Access Compliance Report

Public Rights-of-Way

(Curb Ramps)

Intersection ID: 27563	Main Street: BALLANTYNE_FOREST_DR	Cross Street: LEDERER_AV	Location: N
ADA ID: 441EAE436C1E	Ramp Type: Perp	Initial Pass/Fail: Fail	Overall Compliance: No
Severity Score: 33.75			
Codes/Mitigation Info/Possible Solution		Field Measurements/Component Compliance

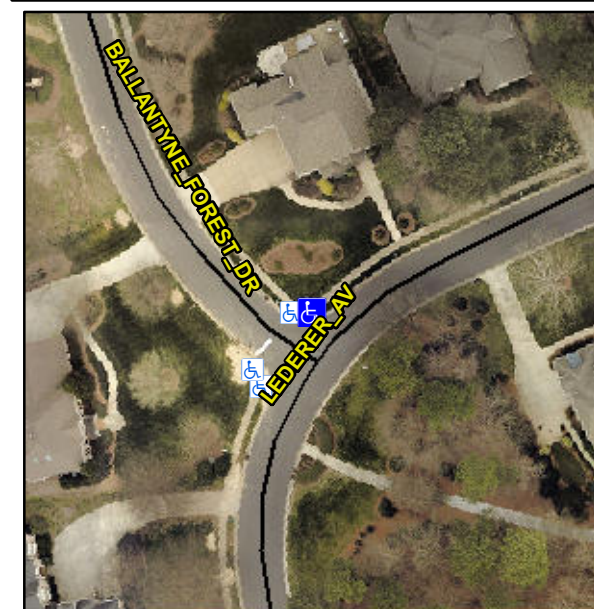
Not Found, R304.5.1, R304.2.2, R304.5.3

Compliance	Description	Data	Compliance	Description	Data
N/A	Ramp Length (in)	92.0	No	Ramp Slope (%)	9.2
No	Ramp Width (in)	39.0	No	Ramp XSlope (%)	6.3
N/A	Flare Type LT	N/A	N/A	Flare Type RT	N/A
N/A	Flare Slope LT (%)	N/A	N/A	Flare Slope RT (%)	N/A
N/A	Flare Traversable LT?	N/A	N/A	Flare Traversable RT?	N/A
N/A	Landing Length (in)	N/A	N/A	DWS Provided?	N/A
N/A	Landing Width (in)	N/A	N/A	DWS Contrast?	N/A
N/A	Landing Slope (%)	N/A	N/A	DWS Length (in)	N/A
N/A	Landing X Slope (%)	N/A	N/A	DWS Full Width?	N/A
N/A	Landing Curb? (Y/N)	N/A	N/A	DWS Offset (in)	N/A
N/A	Shared Landing?	N/A			
N/A	Gutter Ponding?	N/A	N/A	Gutter Slope (%)	N/A
N/A	Gutter Lip Ht (in)	N/A	N/A	Gutter X Slope (%)	N/A
N/A	Painted X Walk1?	No	N/A	Painted X Walk2?	N/A
	X Walk 1 Direction	To SE		X Walk 2 Direction	N/A
N/A	X Walk 1 Width (in)	N/A	N/A	X Walk 2 Width (in)	N/A
	X Walk 1 Slope (%)	1.6		X Walk 2 Slope (%)	N/A
	X Walk 1 X Slope (%)	4.0		X Walk 2 X Slope (%)	N/A

Remove & Replace Entire Ramp.
